Council Assessment Panel Agenda & Reports

17 July 2023

5. DEVELOPMENT APPLICATIONS – PDI ACT

Figure 11: Southern Treatments

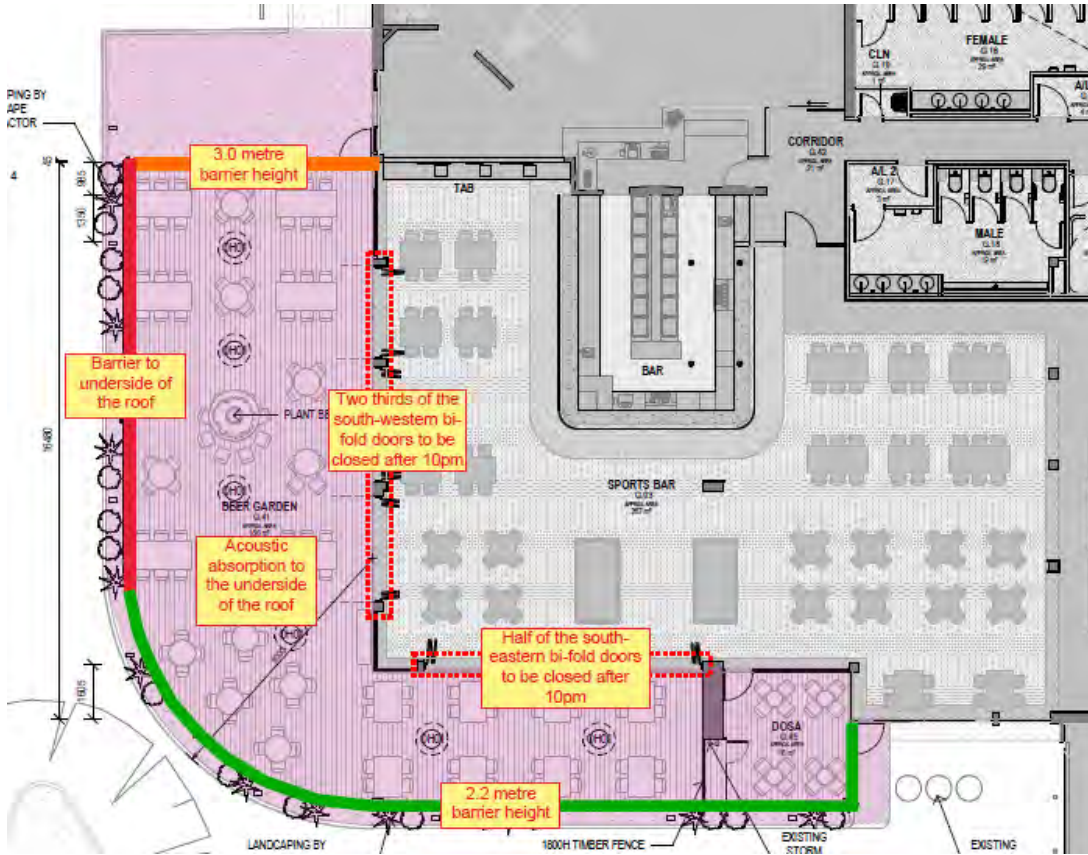
(C) In figure 11 of the Southern exposure (on URPS page 16), it shows that “Two thirds of the south-western bi-fold doors to be closed AFTER 10pm”, and “Half of the south-eastern bi-fold doors to be closed AFTER 10pm”. This differs from the wording on the previous page (URPS page 15) which reads “Ensure that two-thirds of the south-west facing bi-fold doors and half the south-east facing bi-fold doors into the southern beer garden (indicated in Figure 1 below) REMAIN CLOSED after 10.00pm.”.

Figure 12: Northern Treatments

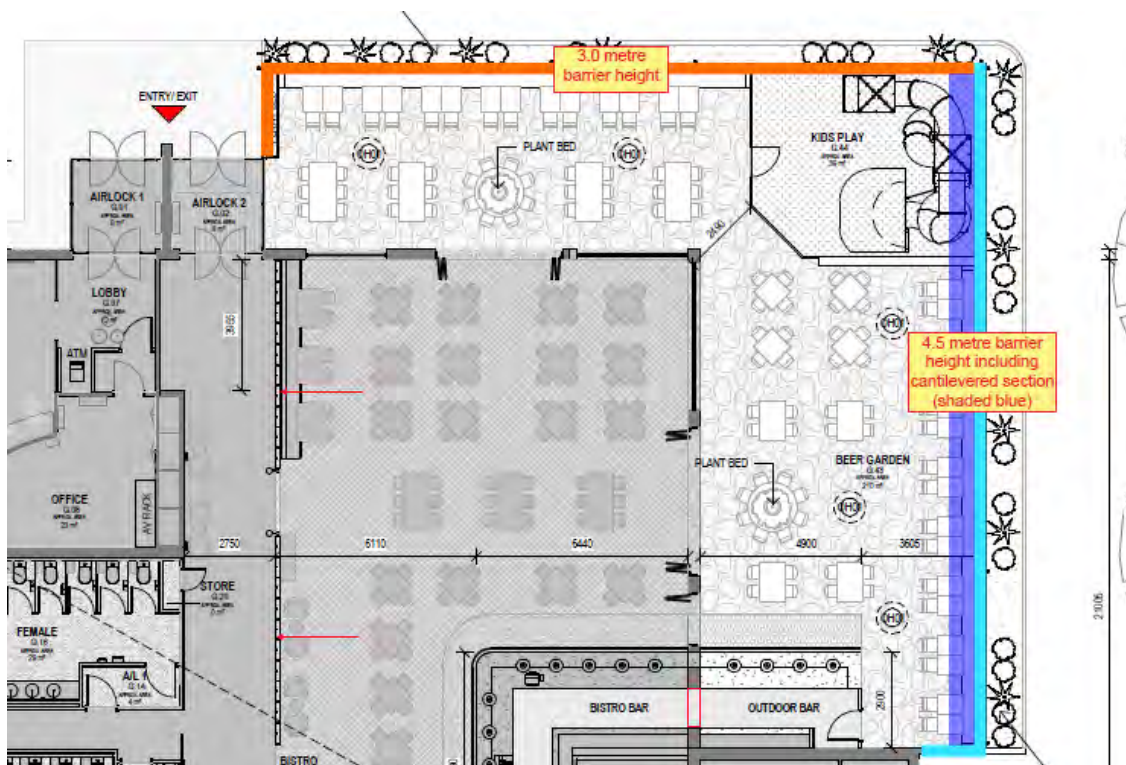
URPS figure 12 (on page 16) shows that the Childrens’ Play Area is to be located in the North-East corner adjacent to the Sports Bar and Sports Beer Garden.

Figure 2 Identification of receivers not assessed

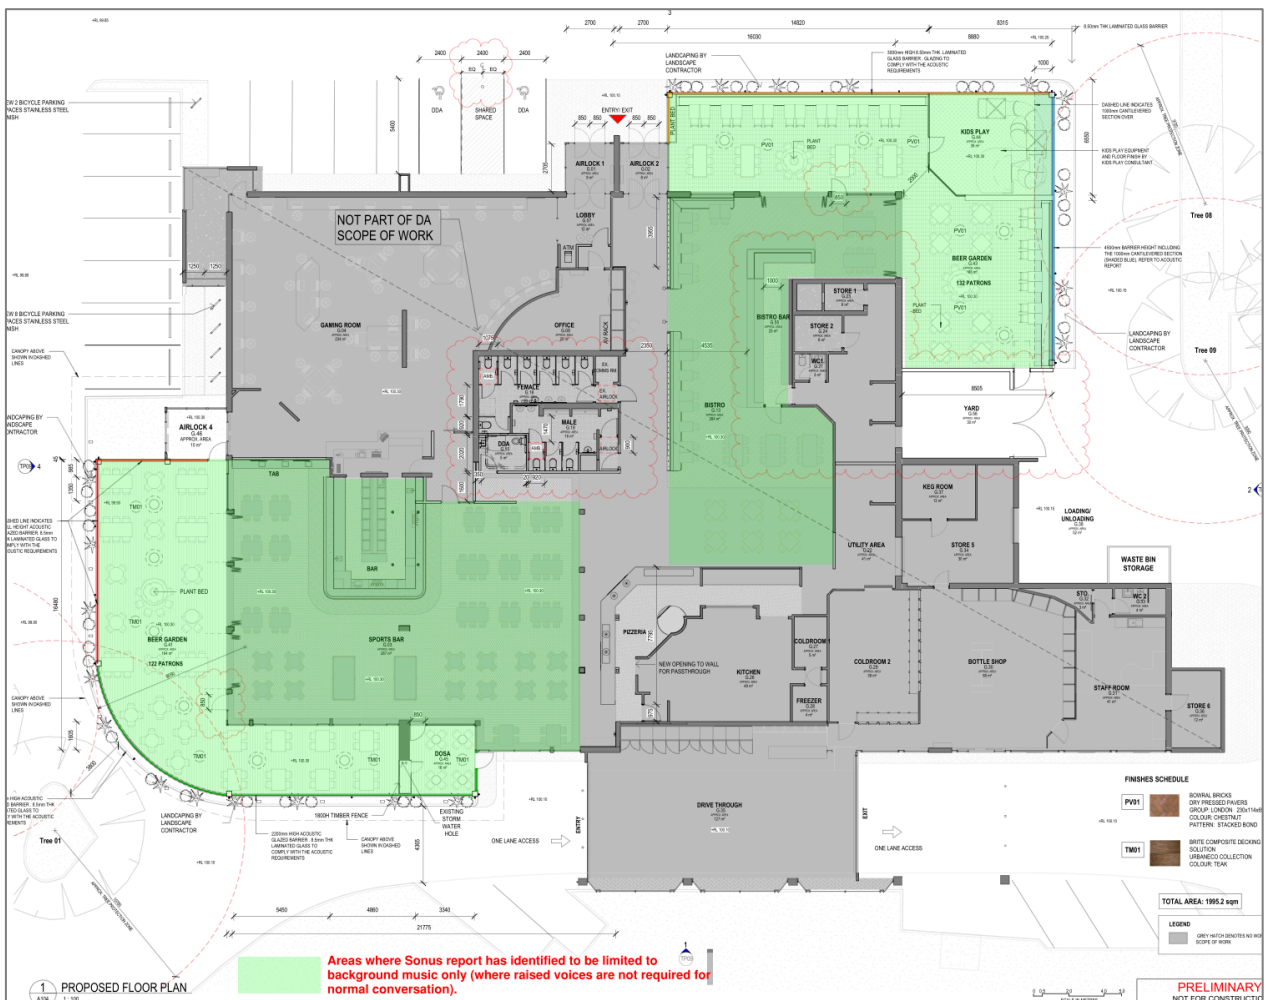
Assessment	<p>It is noted that not all affected noise receptors have been included in the assessment. This is as identified in Figure 2—with the red receivers (A to F) assessed in the Sonus report, with no comment regarding the green receivers.</p> <p>All adjacent receptors should be considered in demonstrating compliance.</p>

Figure 2 Identification of receivers not assessed

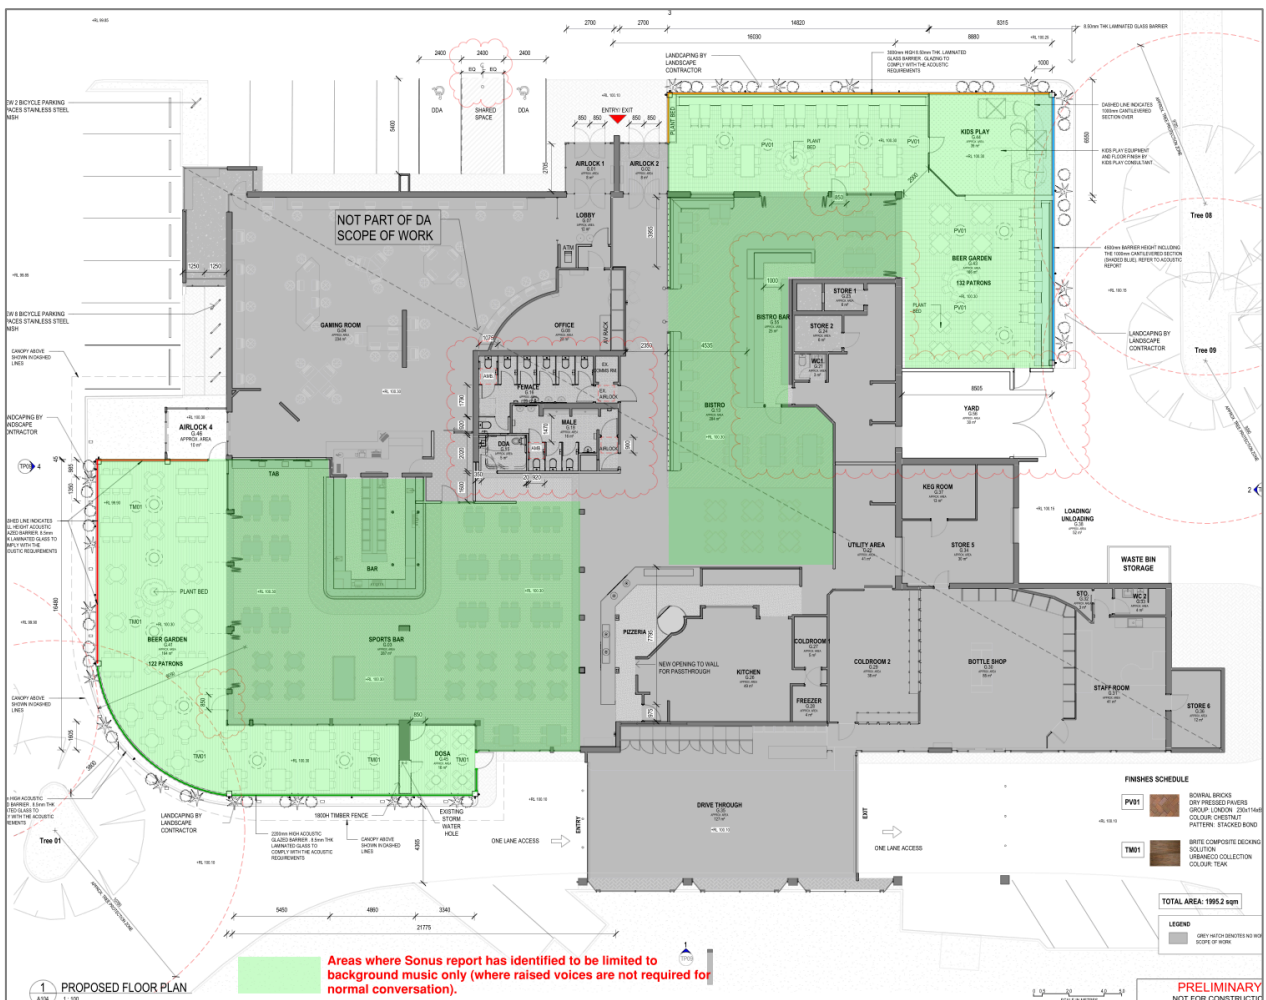
Assessment	<p>It is noted that not all affected noise receptors have been included in the assessment. This is as identified in Figure 2—with the red receivers (A to F) assessed in the Sonus report, with no comment regarding the green receivers.</p> <p>All adjacent receptors should be considered in demonstrating compliance.</p>
